Re: **BID ADDENDUM No. 2**
Phase 1A – Bond Improvements
Bedford Central School District
SED No. 66-01-02-06-0-003-021 (FLHS)
SED No. 66-01-02-06-0-007-011 (FLMS)
SED No. 66-01-02-06-0-006-015 (MKES)
SED No. 66-01-02-06-0-002-016 (BVES)
SED No. 66-01-02-06-0-004-020 (BHES)
SED No. 66-01-02-06-0-009-014 (WPES)
SED No. 66-01-02-06-0-001-016 (PRES)
BBS File No 22-225A-G

The following changes shall be and are hereby made:

A2.01 MKES

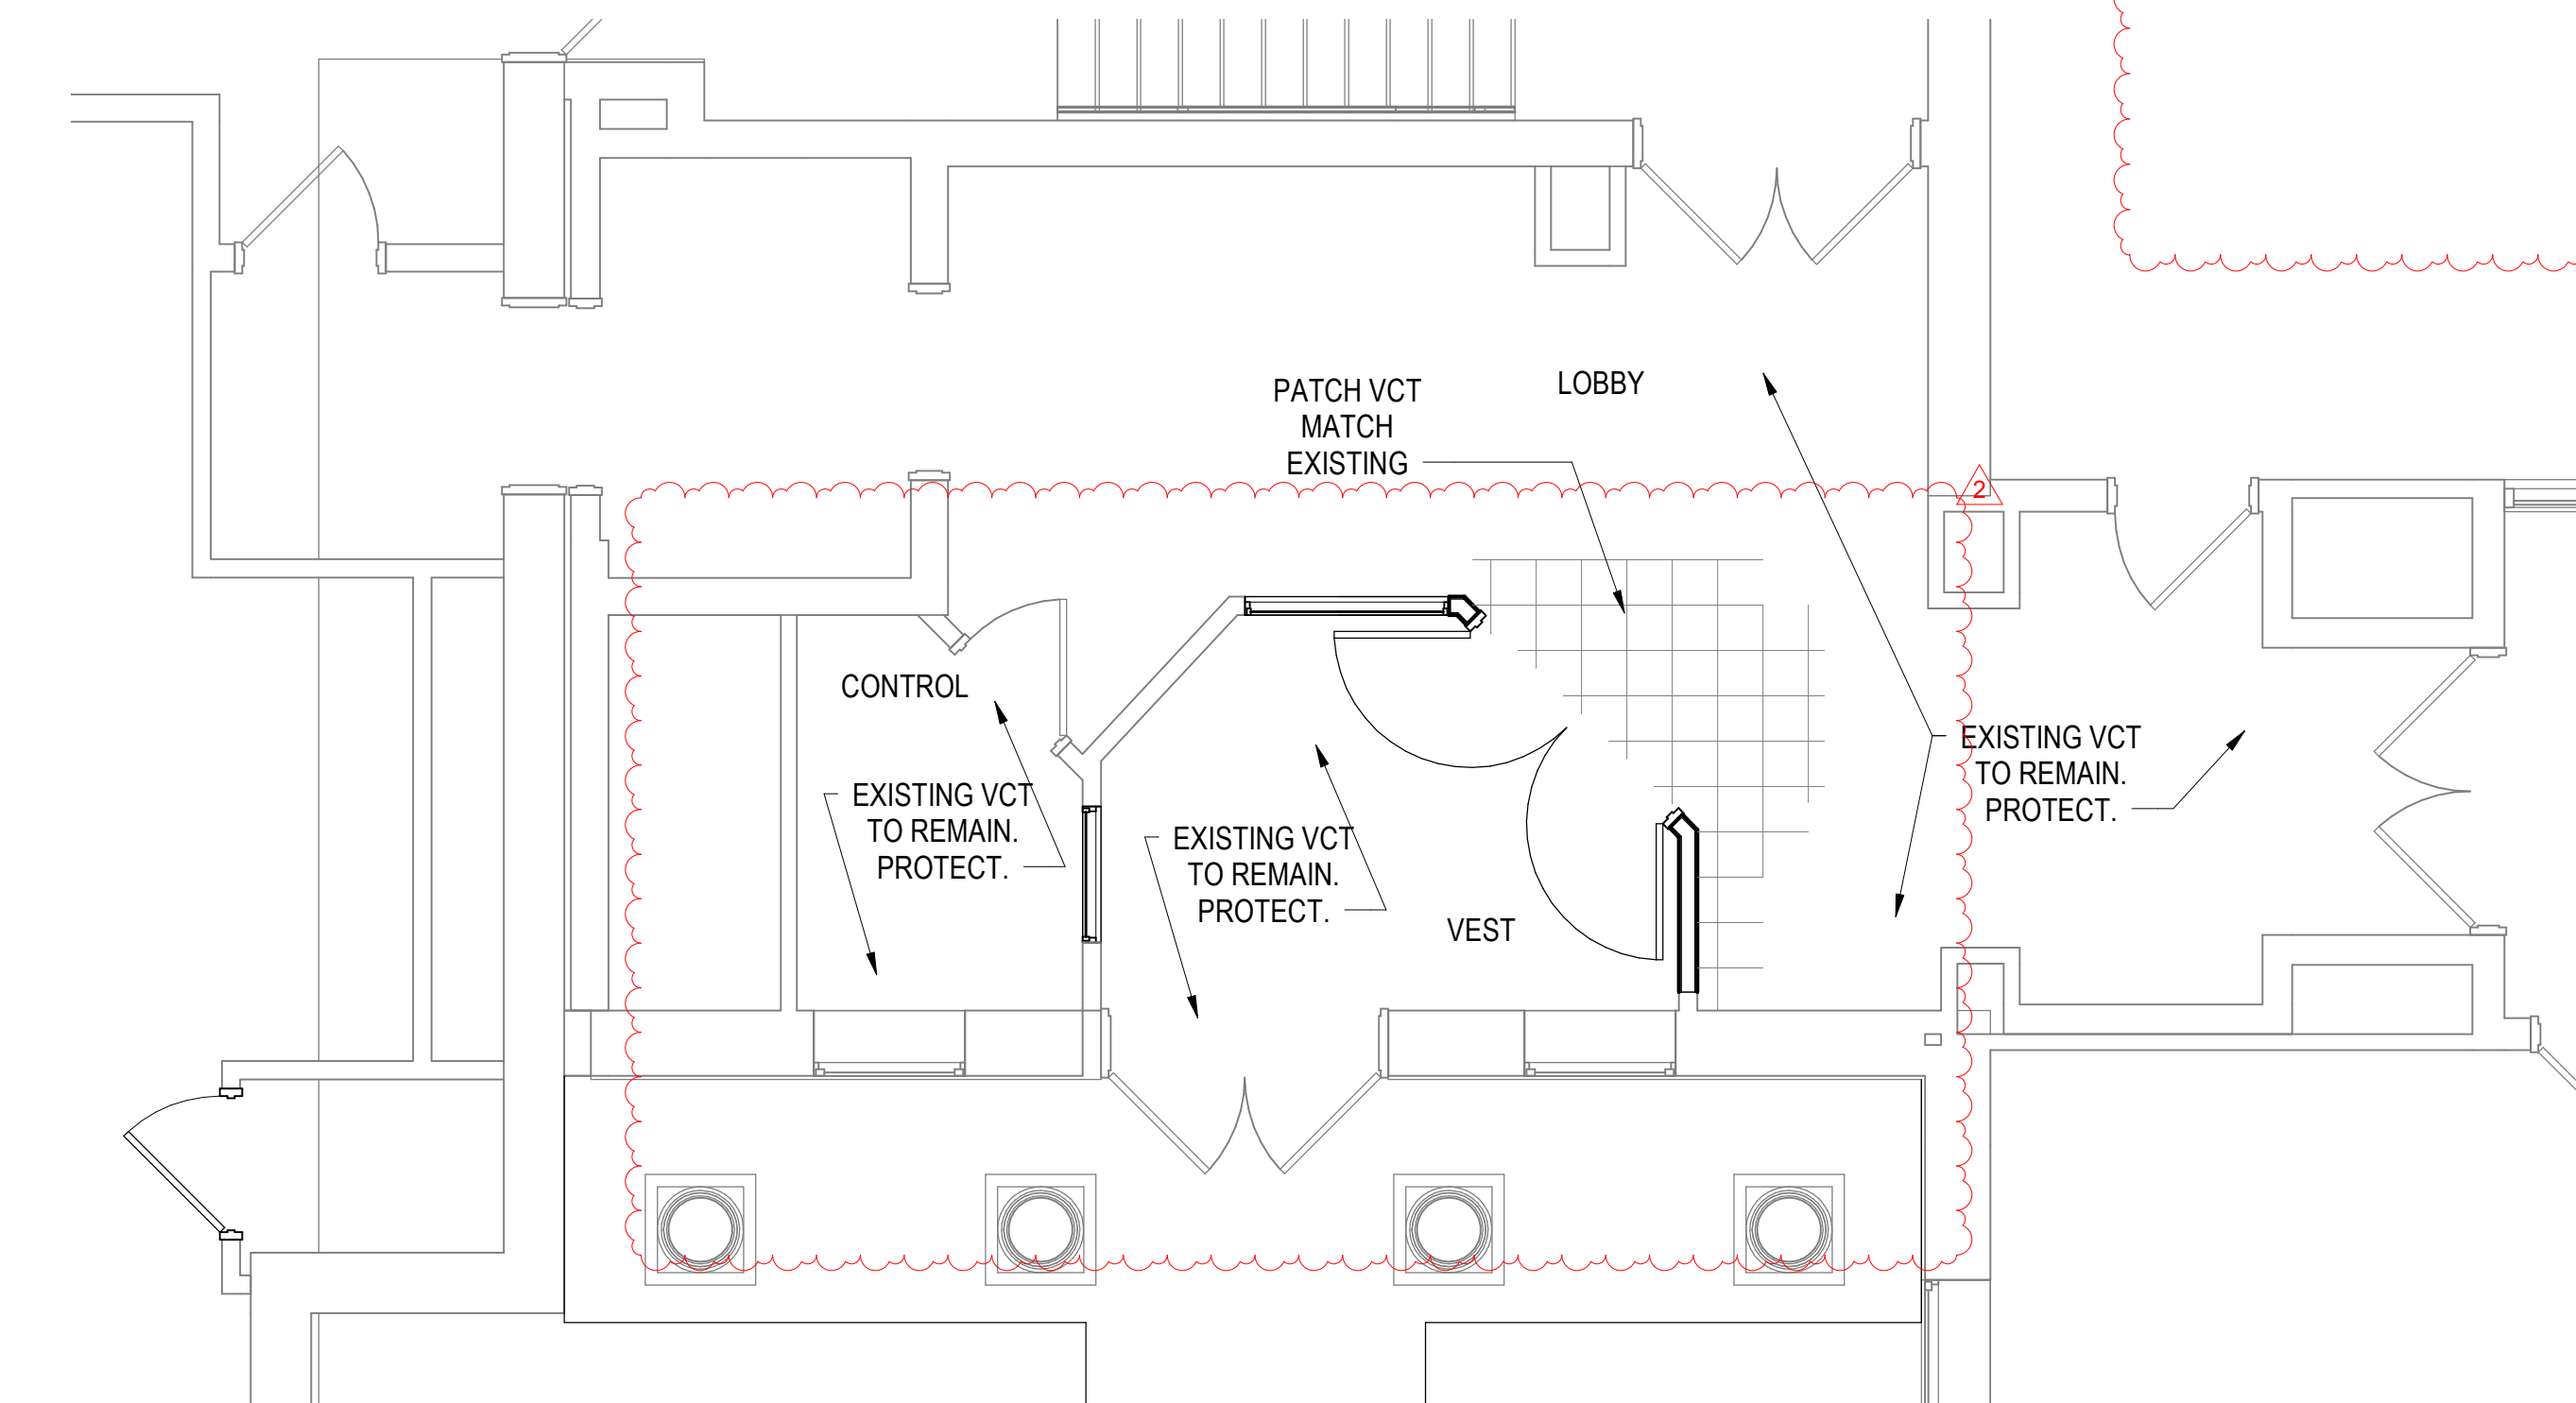
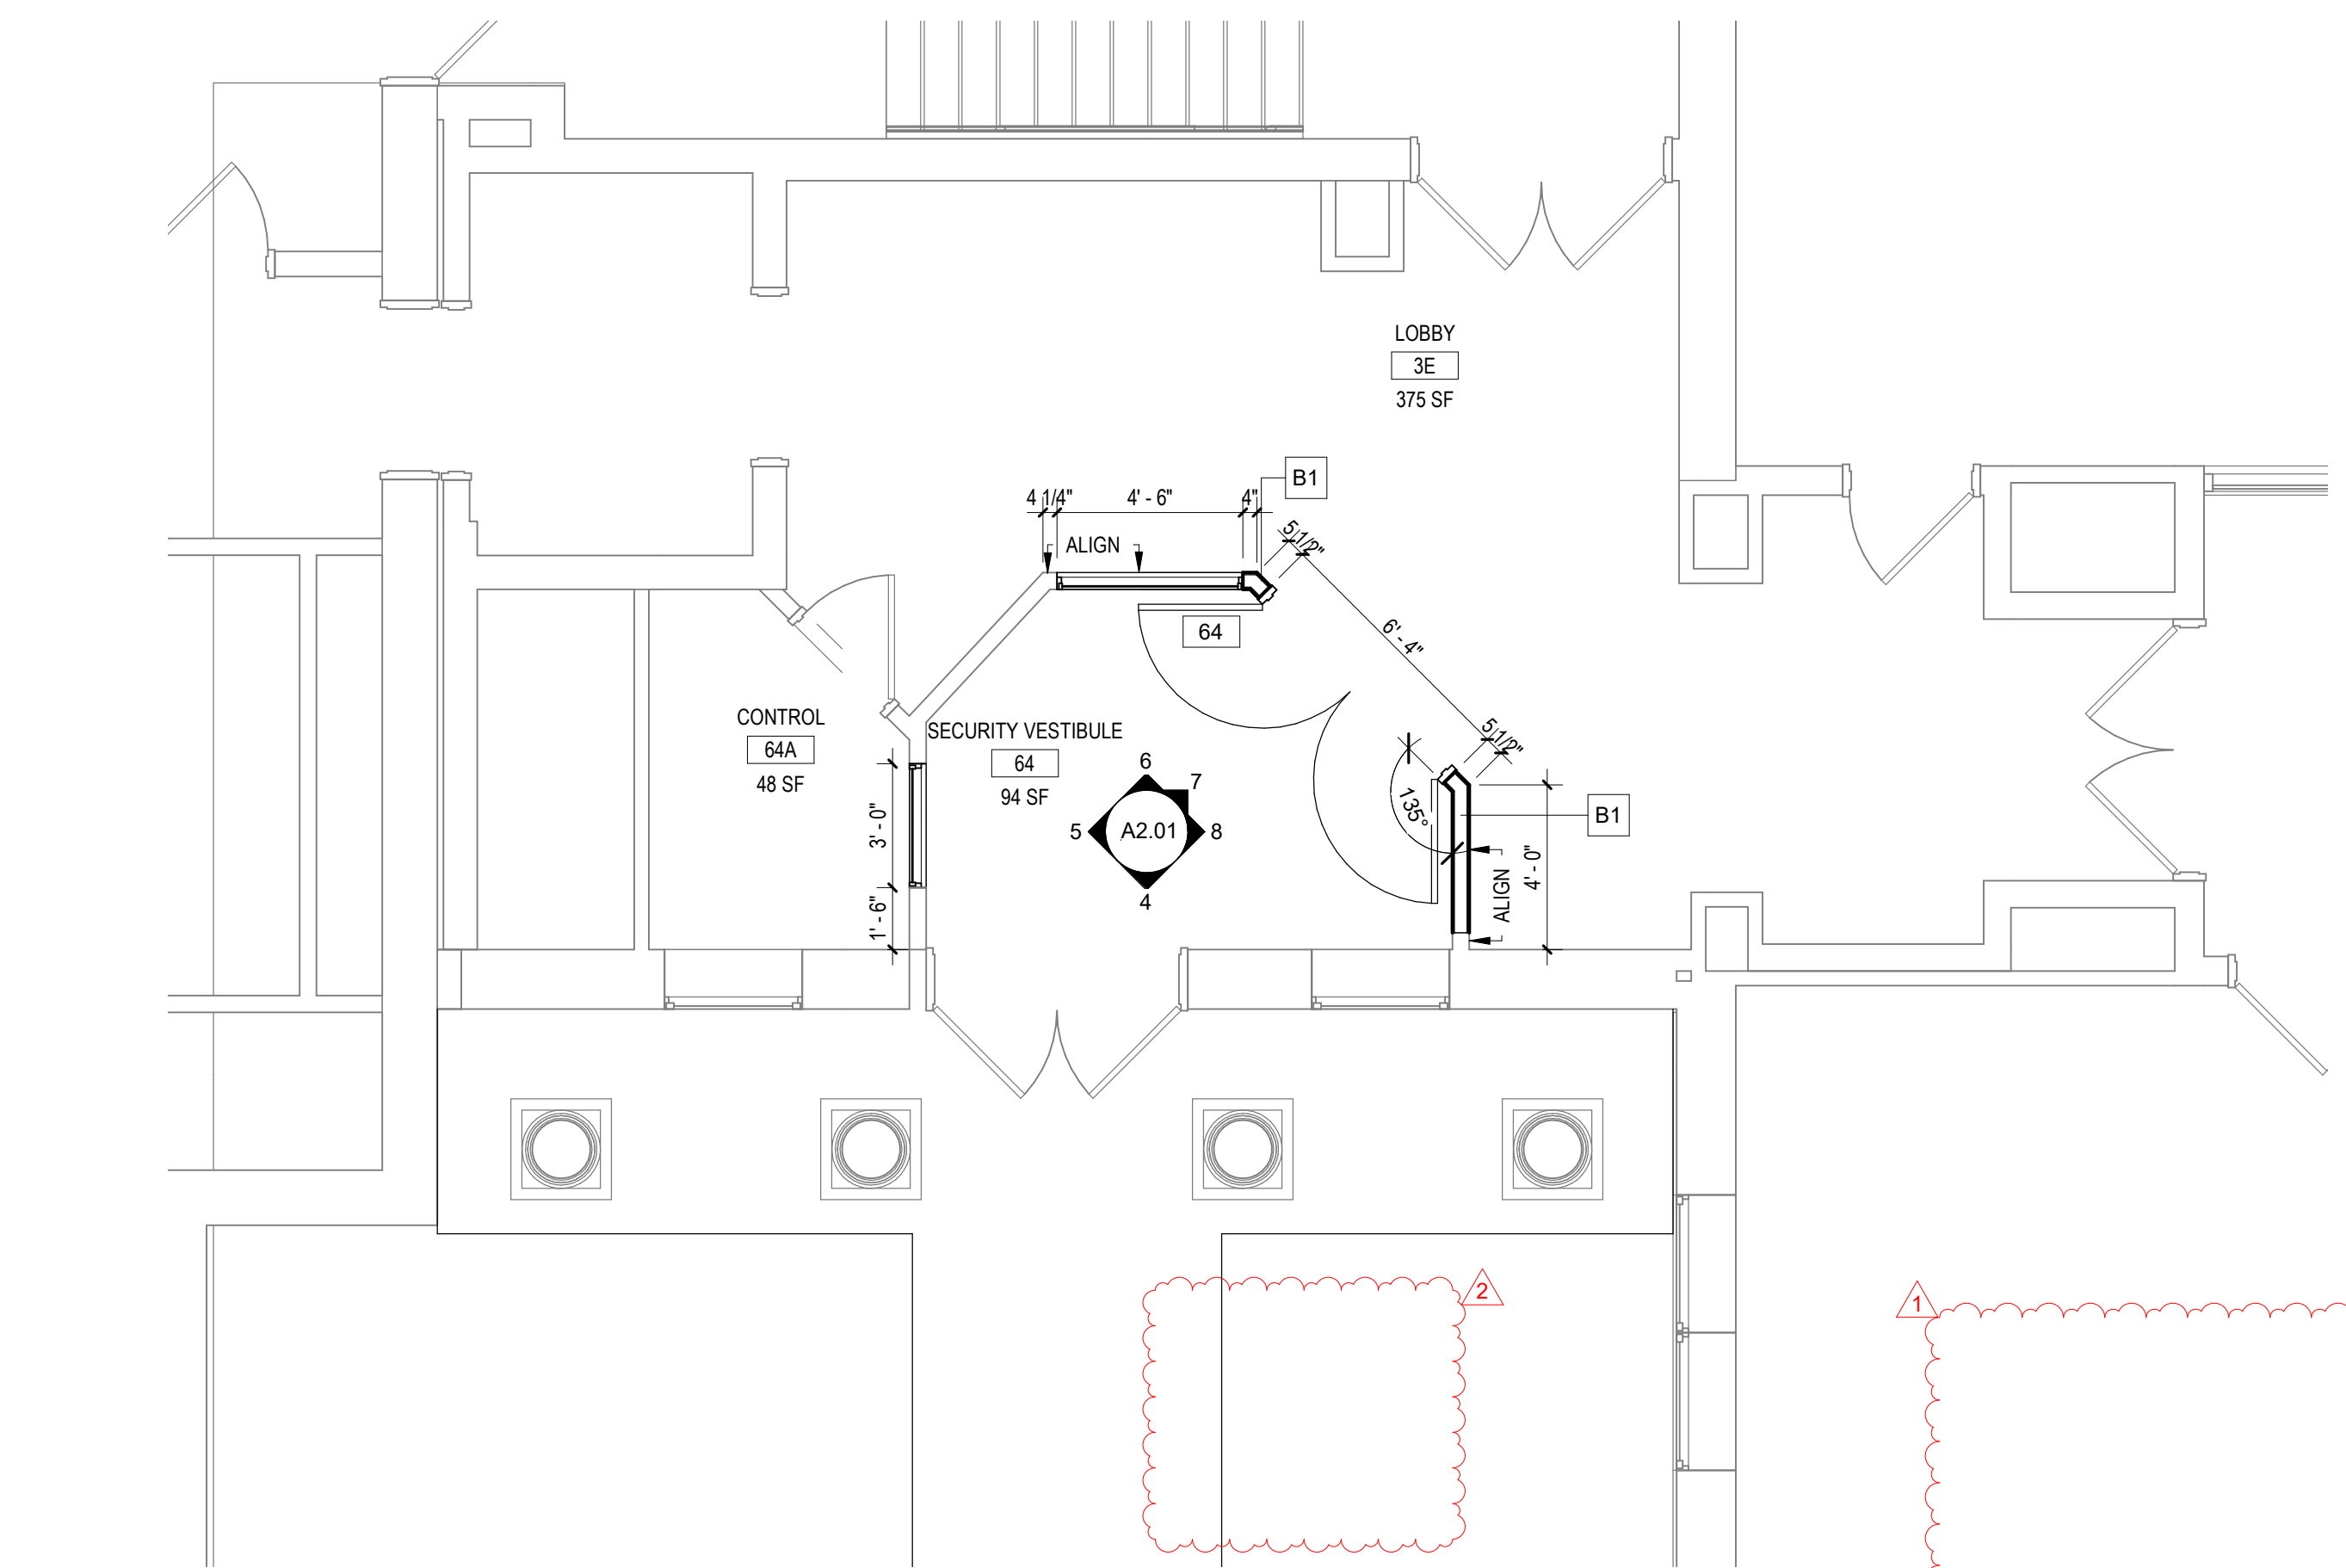
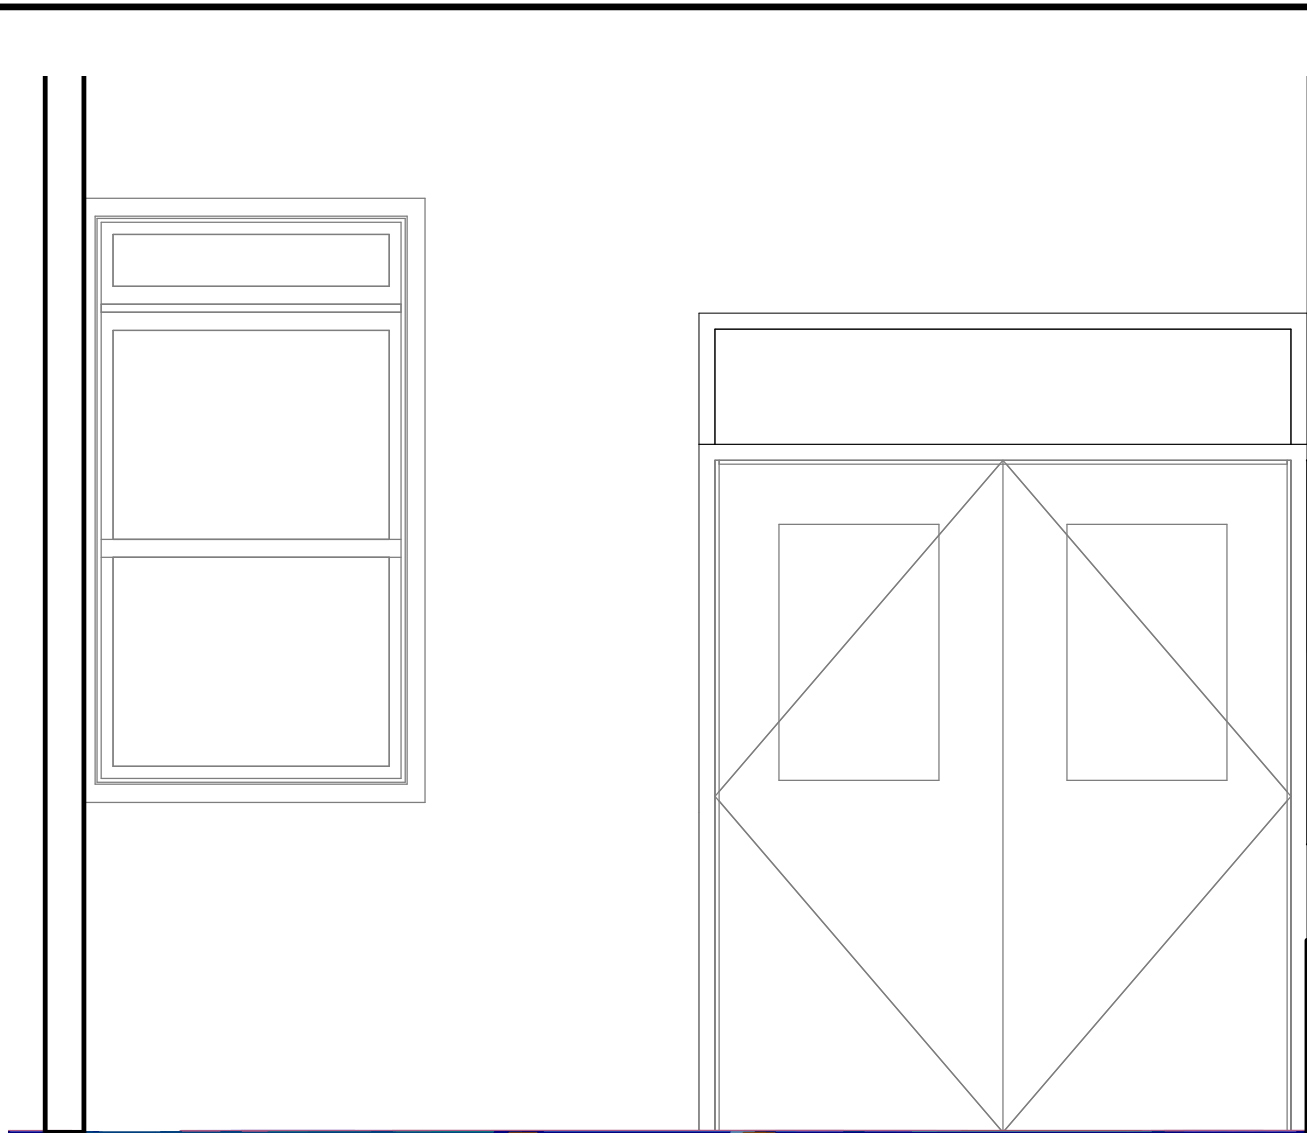
Drawing A1.01 MKES, section 3 notes existing drywall ceiling and VCT floor to remain and protect. Drawing A2.01 MKES, section 1 and 3 shows new ACT drop ceiling and LVT/VCT/T1 floor finishes. Please confirm existing ceiling and walls remain and new finishes installed over existing.

Please provide details for new concrete walk on A2.01 MKES, section 2.

MKES -_A2.01 Please provide drawings, sections, details and specifications for new concrete walk

BBS Response: Refer to revised drawing.

BBS Response: Concrete walk shall be omitted. Refer to revised drawing in this addendum.

BBS Response: Concrete walk at Mt. Kisco shown on A2.01 shall be omitted from bid.
